Application: Lot 56 4th Addition to Nine Springs – Article 5

Review Date: November 15, 2016

Planning Staff Review #1

**Vista 1 Building – Lot 56 Fourth Addition to Nine Springs
51xx E. Cheryl Parkway
Public Works Review #1**

2 TYPICAL STREETSCREEN
C-1.1 NOT TO SCALE

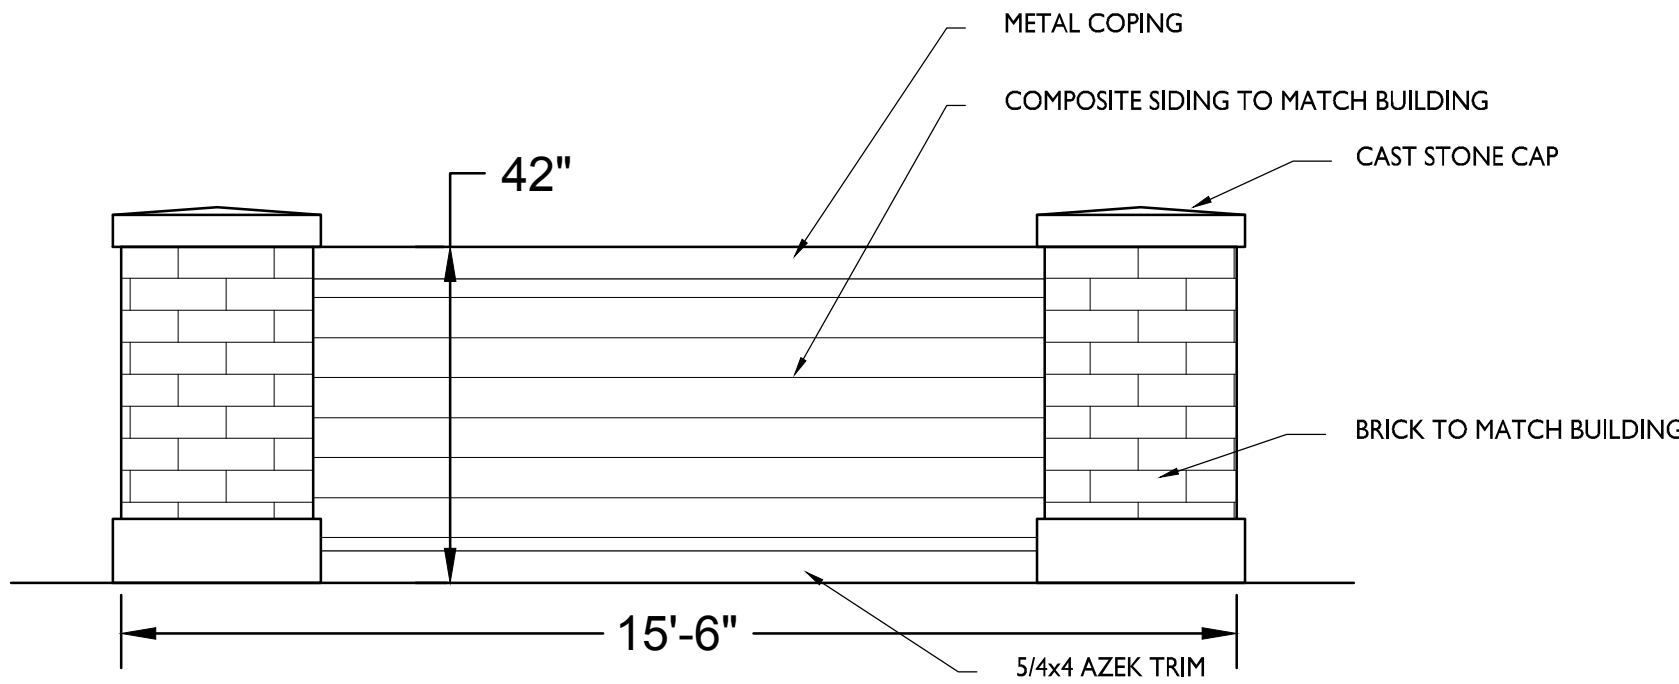
- 8.) A streetscreen is required along any portion of the frontage line where there isn't a building. Please update the site plan to show location of streetscreens and also provide a streetscreen detail.

- 9.) Open parking shall be masked from the frontage by a building or streetscreen between 3.5 and 5.0 ft in height. Please update the site plan to show location of streetscreens and also provide a streetscreen detail.

RESPONSE: These have been added to the site drawings.

RESPONSE: These have been added to the site drawings.

1 SITE PLAN
C-1.1 1" = 30'-0"

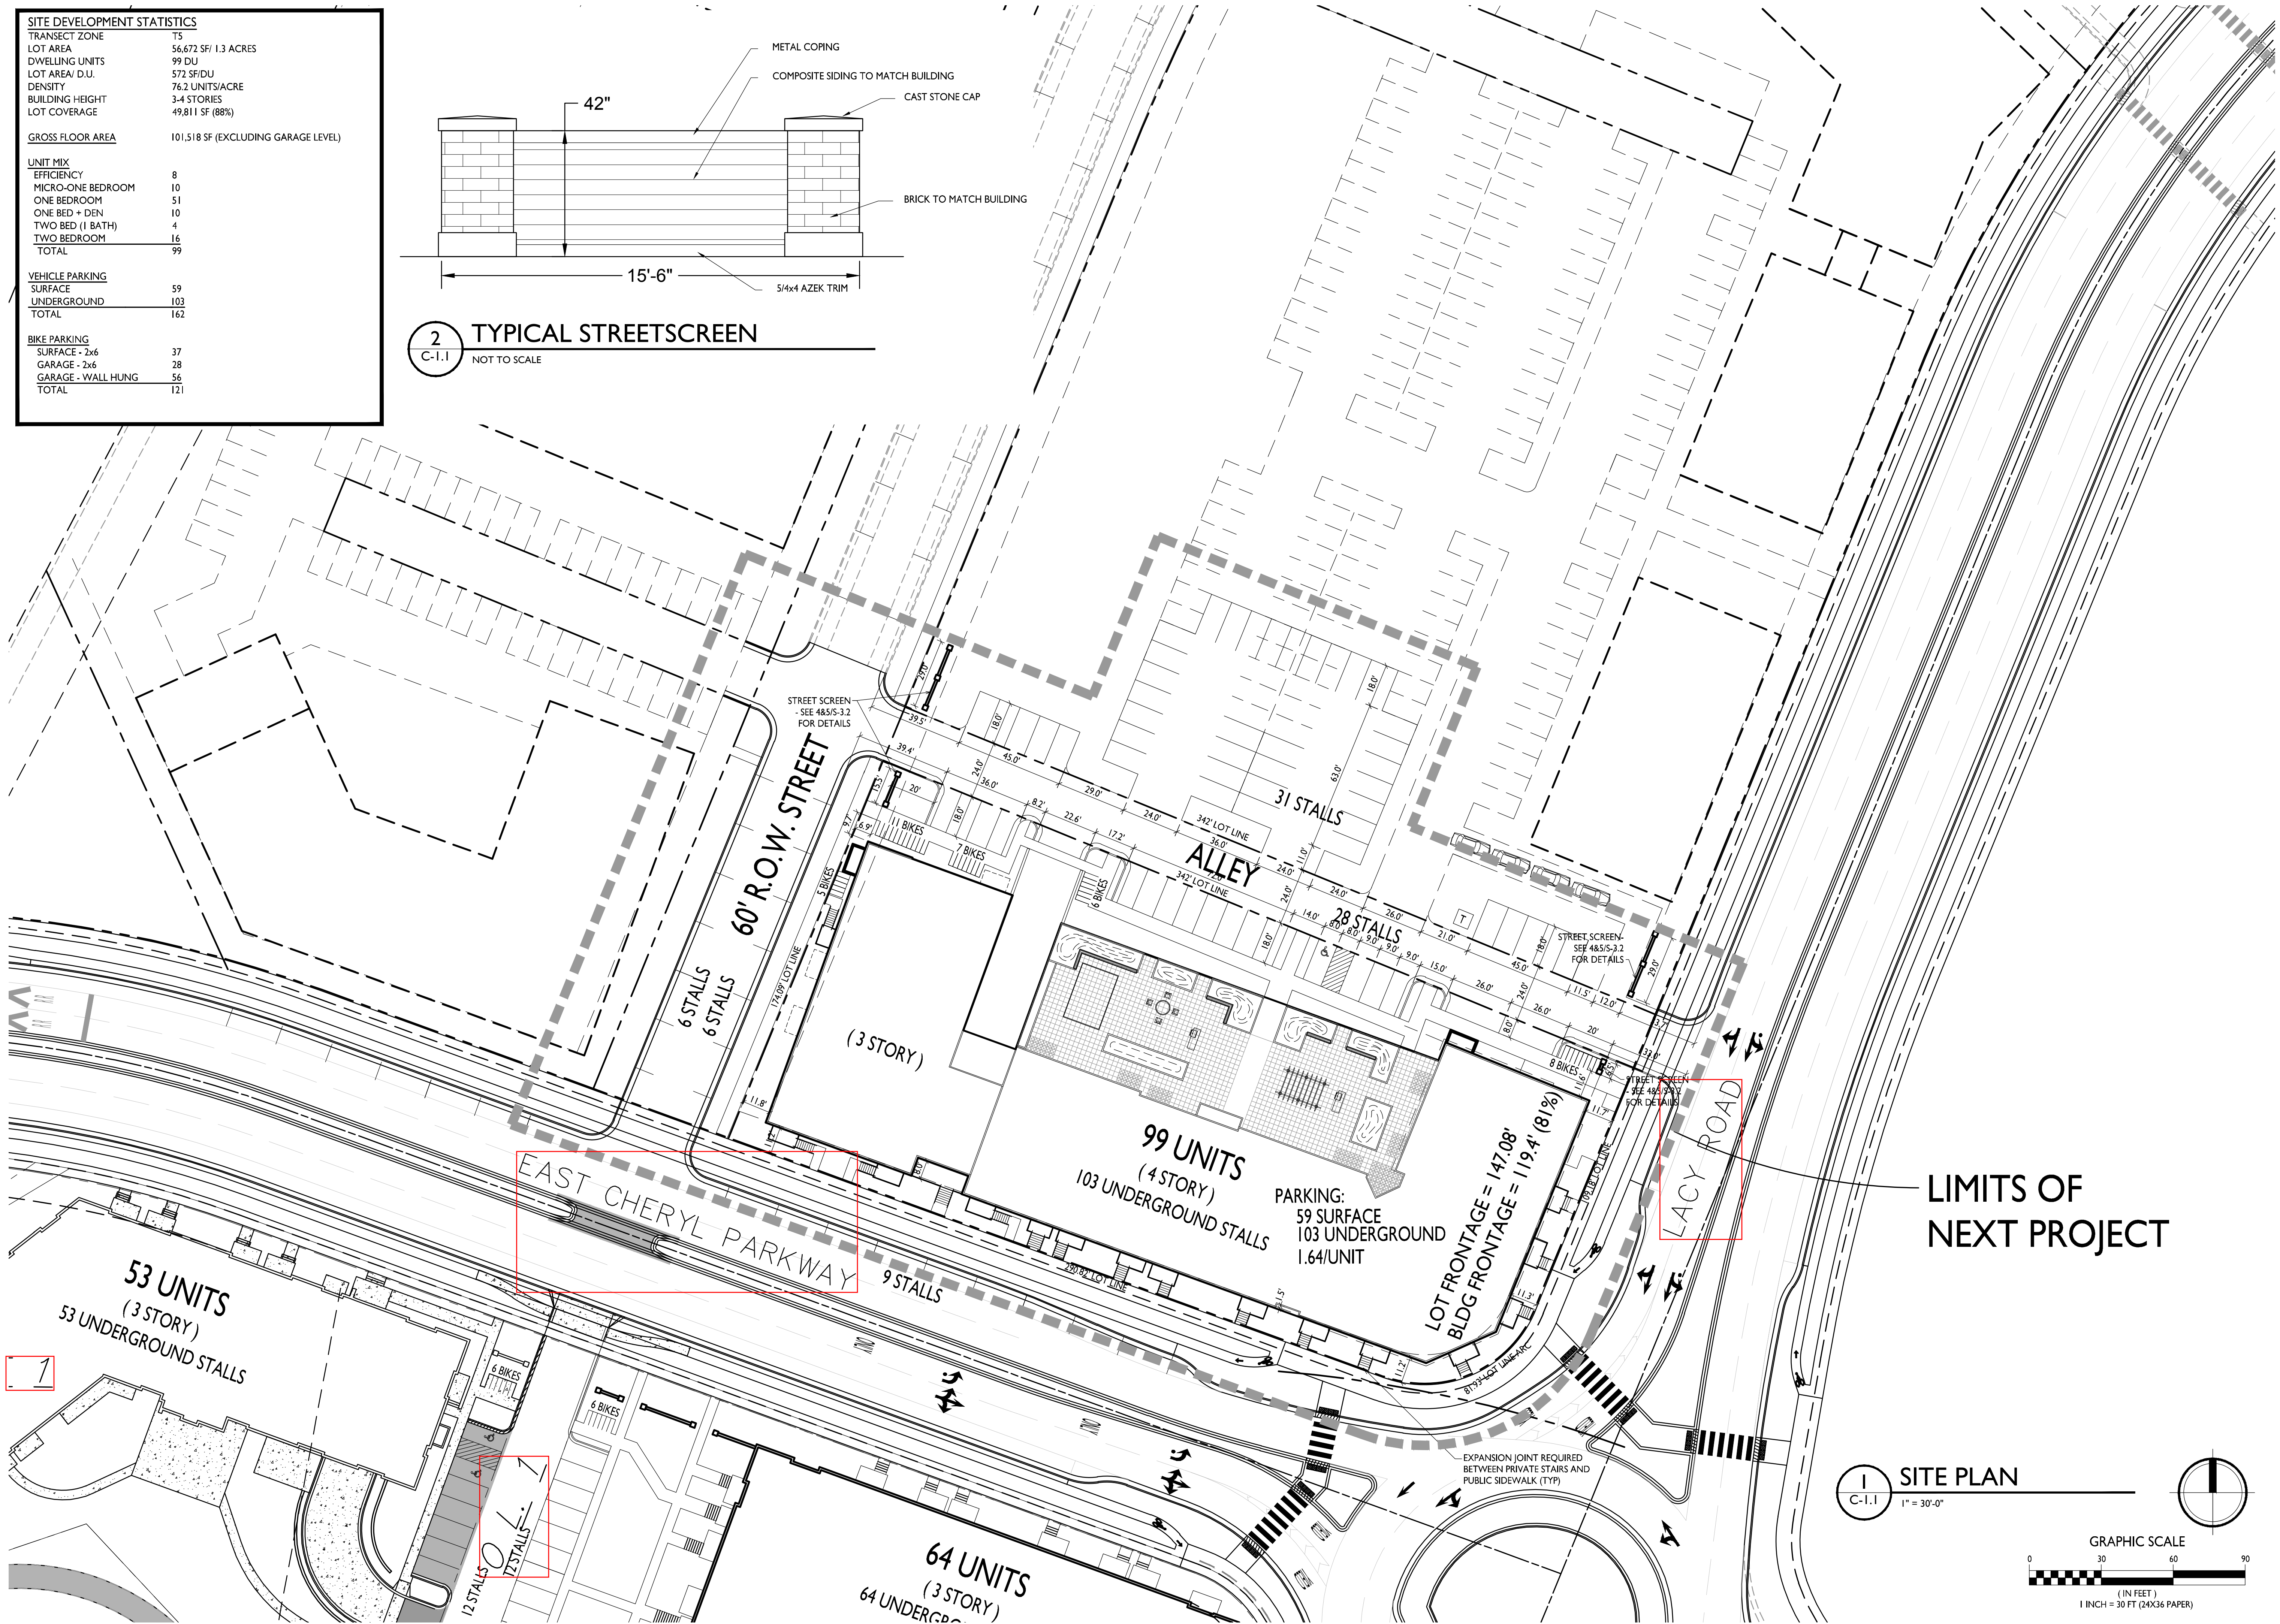
- 2.) Please include the lot dimensions on the site plan.

- 3.) Please provide setback dimension for side setback off alley at NW building near Stanley Park Place.

- 6.) Please dimension the setback of parking stalls off alley from the west property line.

RESPONSE: This has been added to C-1.1.

RESPONSE: This has been added to C-1.1.

RESPONSE: This has been added to C-1.1.

1 SITE LIGHTING PLAN

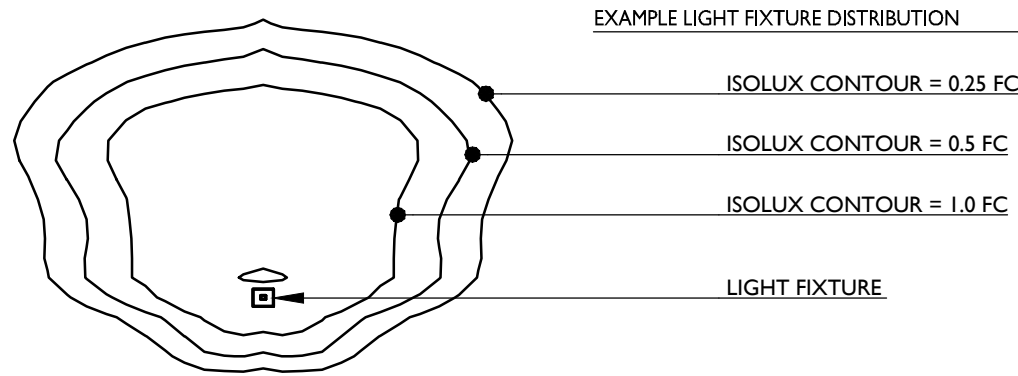
- 14.) C-1.2 lighting plan shows lighting in the parking lot and a light at the parking garage entrance. Is there any other exterior lighting for the site?

RESPONSE: There will be bollard lighting on the plaza to light the pedestrian path to the main entry and there will also be emergency lighting above every exterior exit door as required by code.

1 BASEMENT FLOOR PLAN
A-1.0 3/32" = 1'-0"

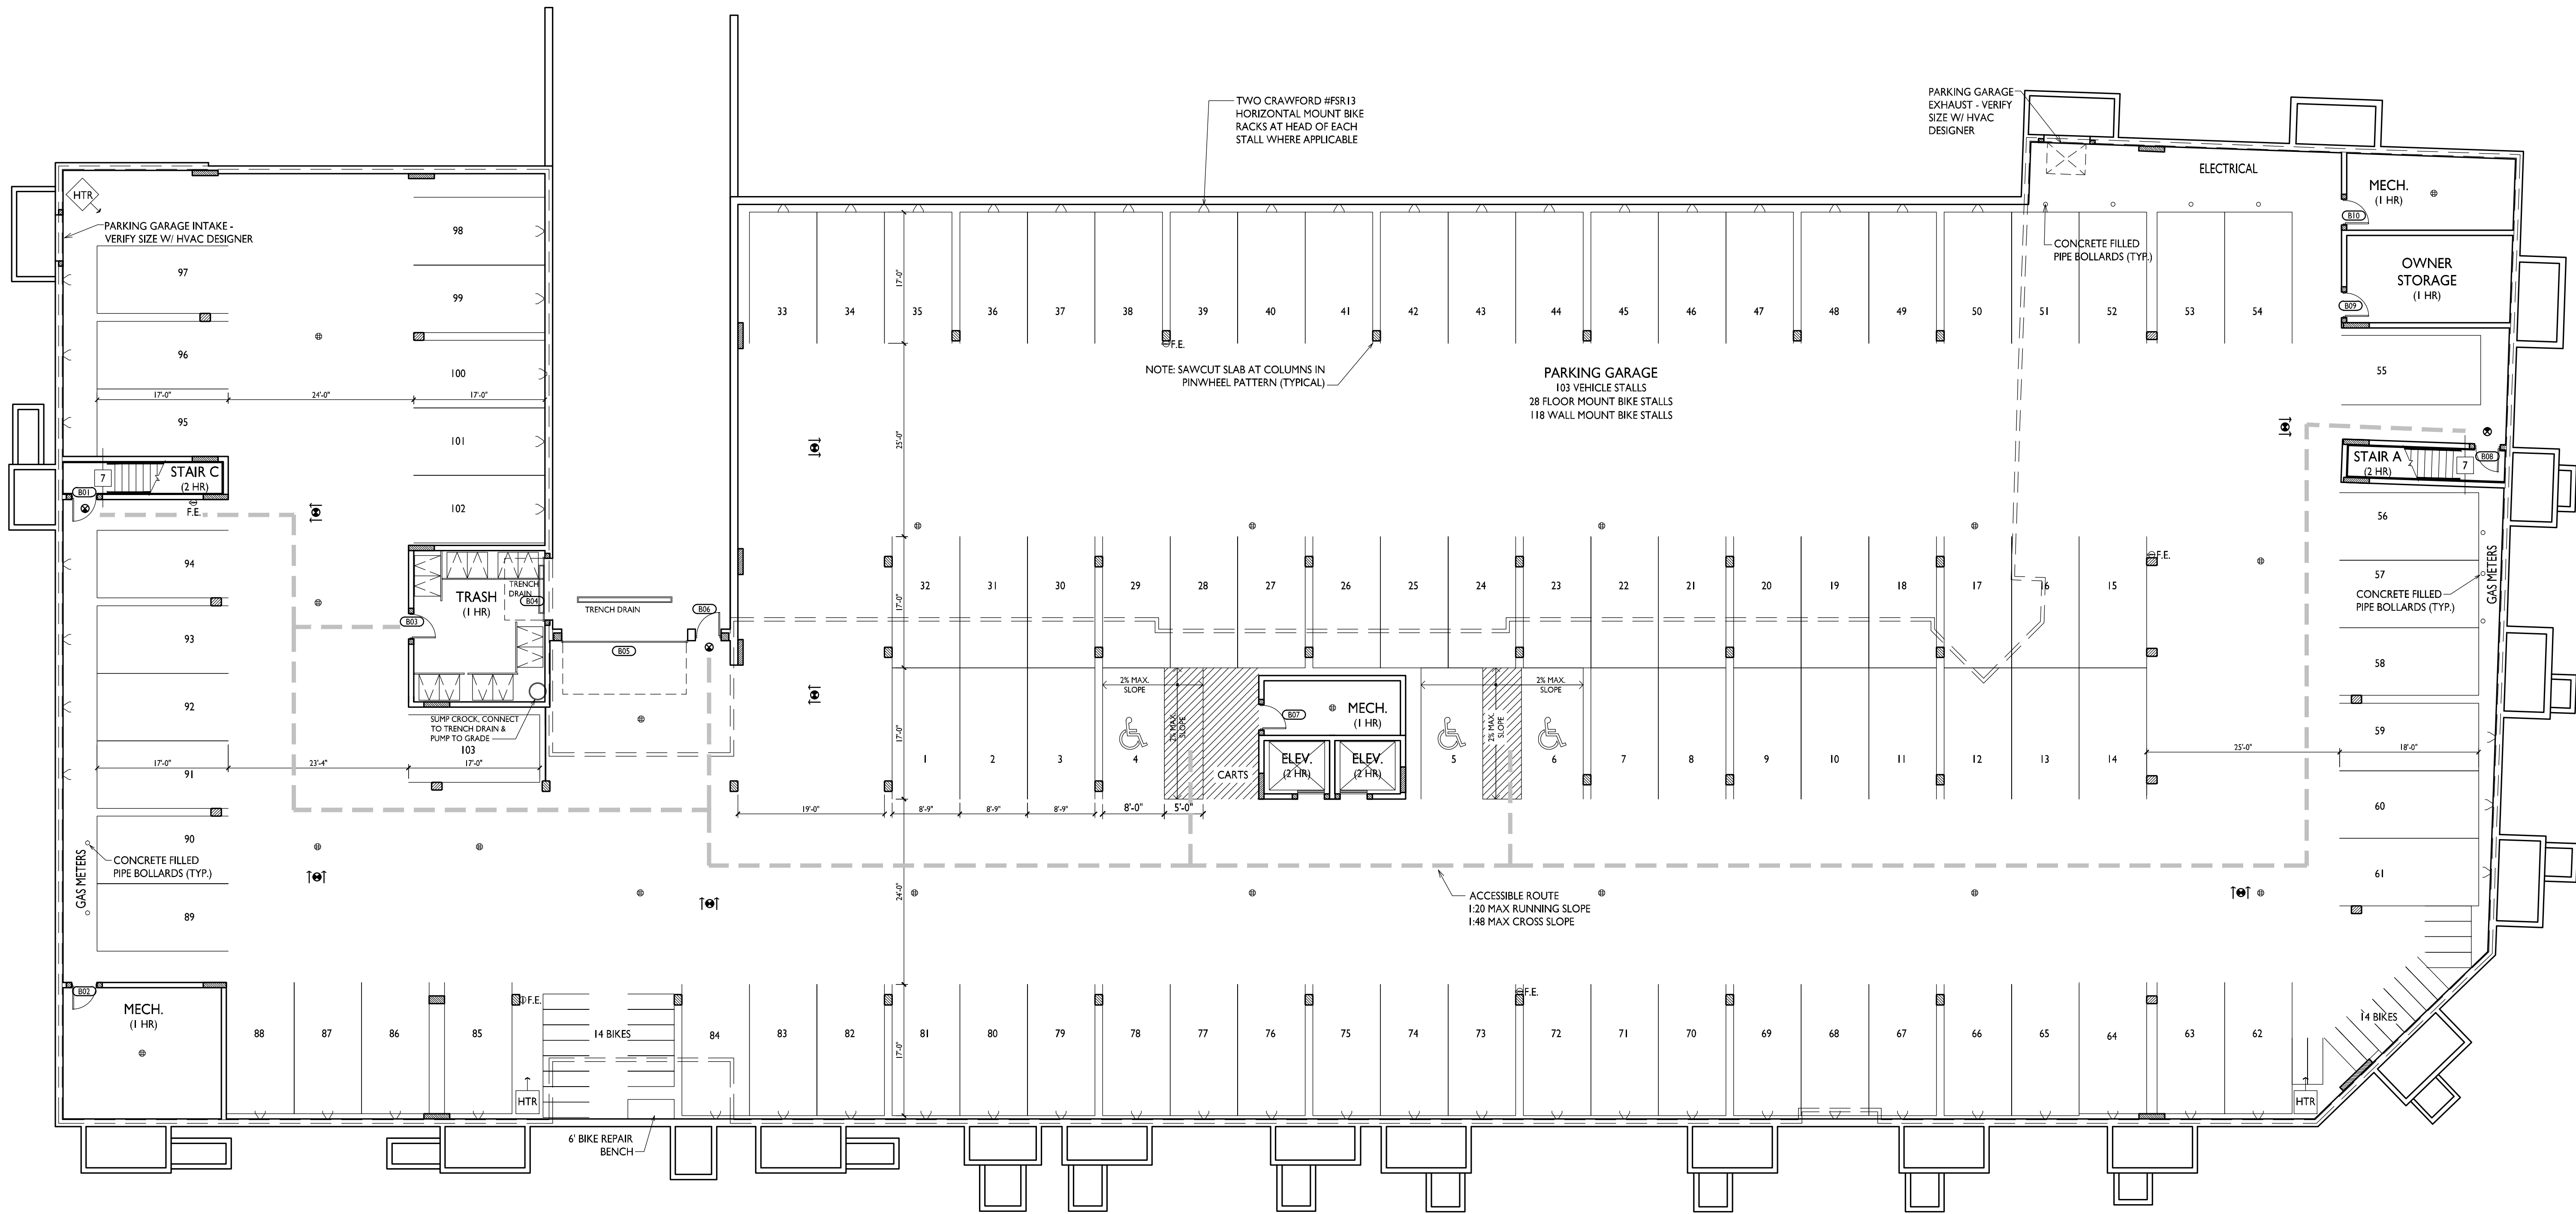
- 10.) Based on the proposed plan, 35 short-term bicycle stalls and 62 long-term bicycle stalls are required. The site plan shows 38 short-term stalls provided outside, 28 stalls in the basement with racks and indicates horizontal mounted bike racks will be provided where applicable. The horizontal mounted bike racks will need to be provided to satisfy the bike parking requirements.

RESPONSE: These will be installed as noted on A-1.0.

1 SOUTH ELEVATION
A-2.1 3/32"=1'-0"

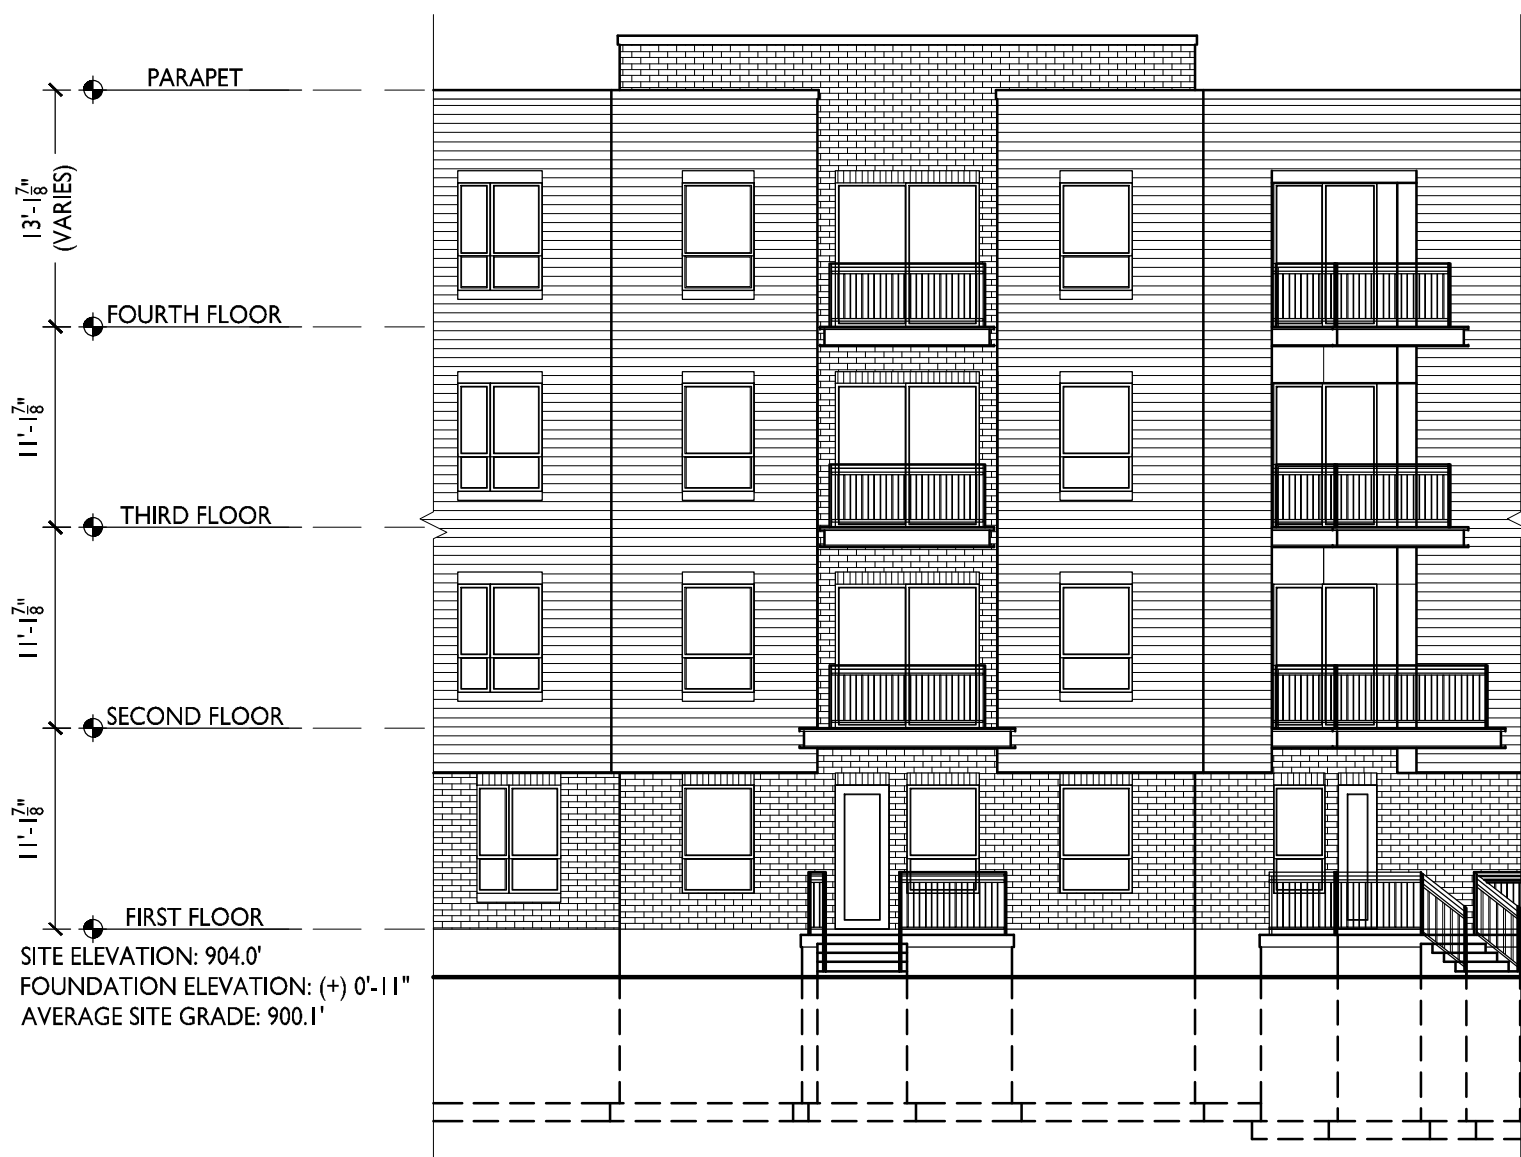
- 4.) The first level of residential should be a minimum of 2' above the average sidewalk grade. The elevations appear to show meeting this, but please provide confirmation that this is being satisfied.

- 12.) Please detail the floor heights on the building elevations.

RESPONSE: This has been confirmed and is noted on C-04 (lower left-hand corner), A-2.1 and A-2.2.

RESPONSE: This has been added to A-2.1 and A-2.2
